Requirements for Measurement Receiver Bandwidth and Jitter Floor

For IEEE 802.3ba, 40G/100G Meeting
May, 2009, Quebec, CA

Issue Statement #1

- Where: D2.0 draft, 83A.5 Electrical parameter measurement methods, P383, L32-37

Measurement Rx Induced DDJ Error As a Function of Its BW

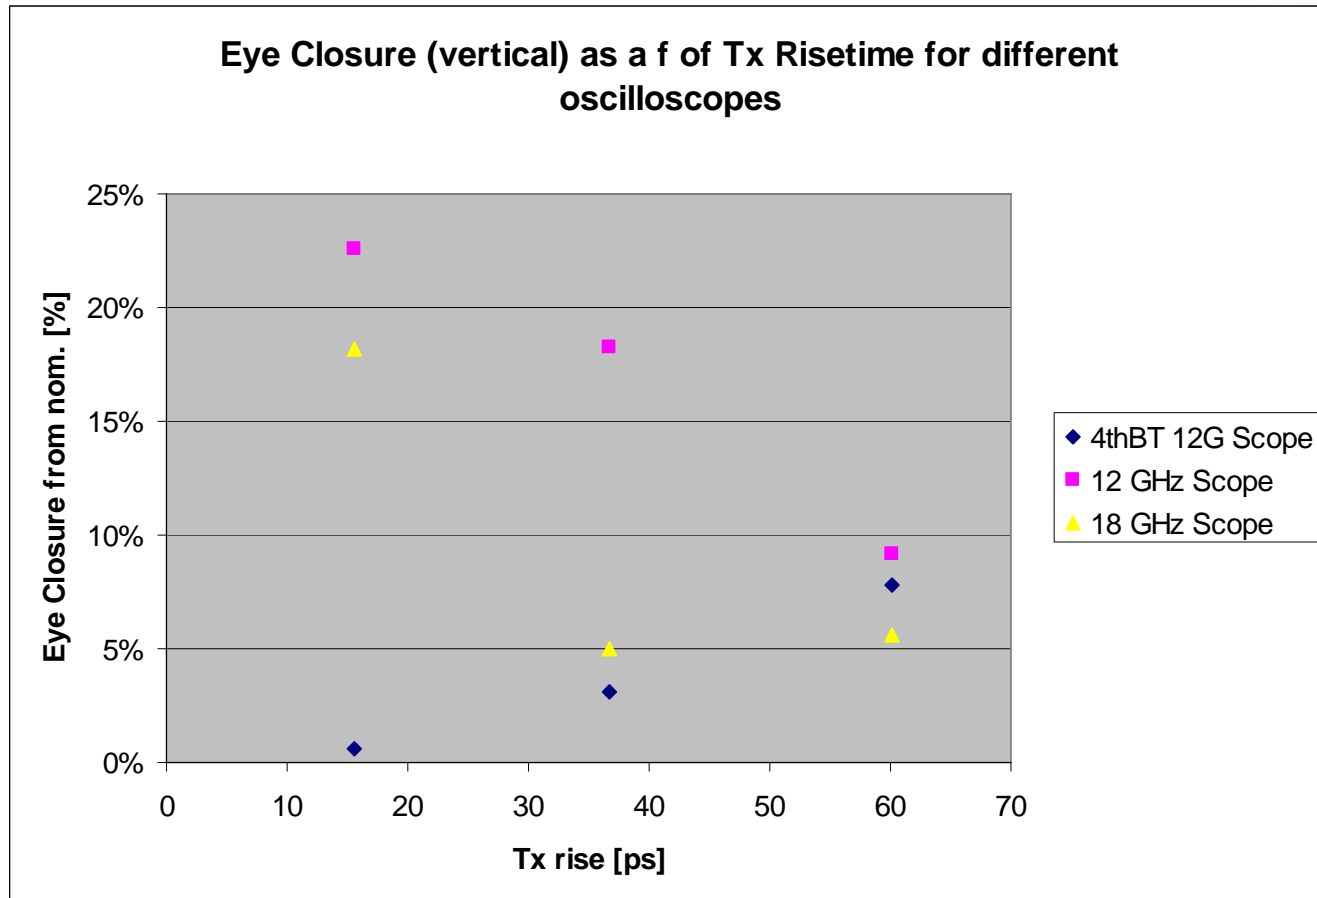
To maintain the minimum error introduced by the measurement equipment such as sampling scope in measuring waveform, eye-diagram, and jitter, a minimum bandwidth (BW) is needed. The rule of thumb is that the BW should be at the 5th harmonic. In the case of 10 Gbps for XALUI/CAUI, it is 25 GHz. The current BW requirement is set at 12 GHz, and it will introduce unacceptable errors.

“the signal waveform, eye, and jitter is measured using a receiver with a minimum -3dB bandwidth of 18 GHz, with a roll-off slope no faster than 20 dB/decade at above 18 GHz ” to cover higher than the 3rd harmonic and this will be the minimum change since 18 GHz scope is very common today.

“the signal waveform, eye, and jitter is measured using a receiver with a minimum -3dB bandwidth of 25 GHz, with a roll-off slope no faster than 20 dB/decade at above 25 GHz ” to cover up to the 5th harmonic and this will give sufficient accuracy.

Effects of Measurement Receiver RJ Floor to the RJ Measurement Results

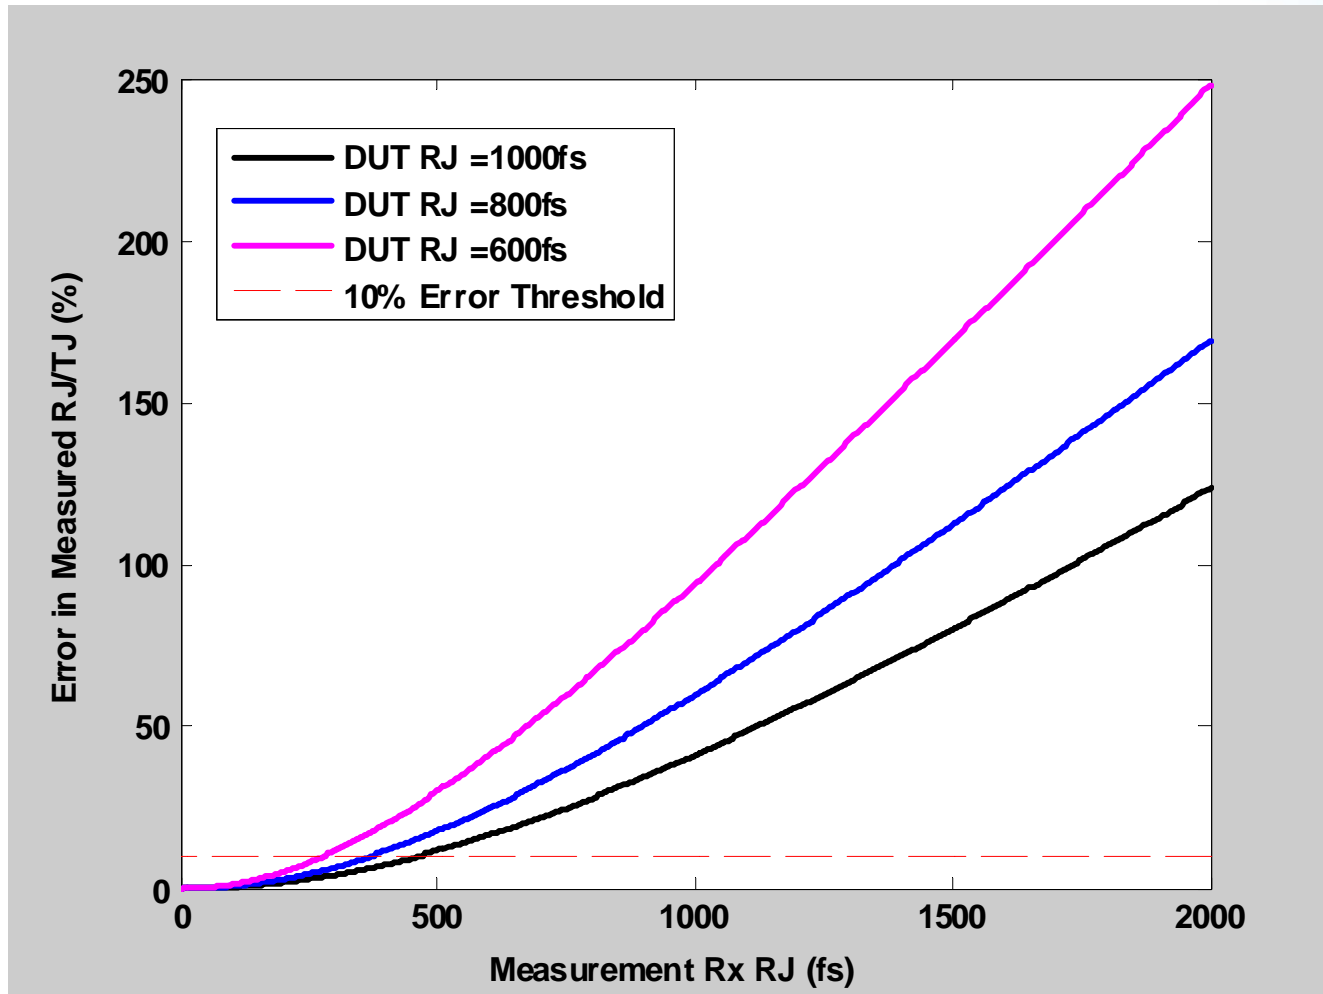
The Tx RJ inferred is at 1.1 ps RMS. There is no requirement on the jitter floor for the measurement receiver. This measurement error will be significant if jitter floor of the measurement receiver is at 1 ps or above.

* Even to maintain a 10% error, RX RJ need to be < 500 fs

- Add a requirement that the measurement receiver needs to have a RJ floor that is 400 fs rms (~ 3 -sigma below the DUT RJ and maintain a $\sim 5\%$ error) or lower.
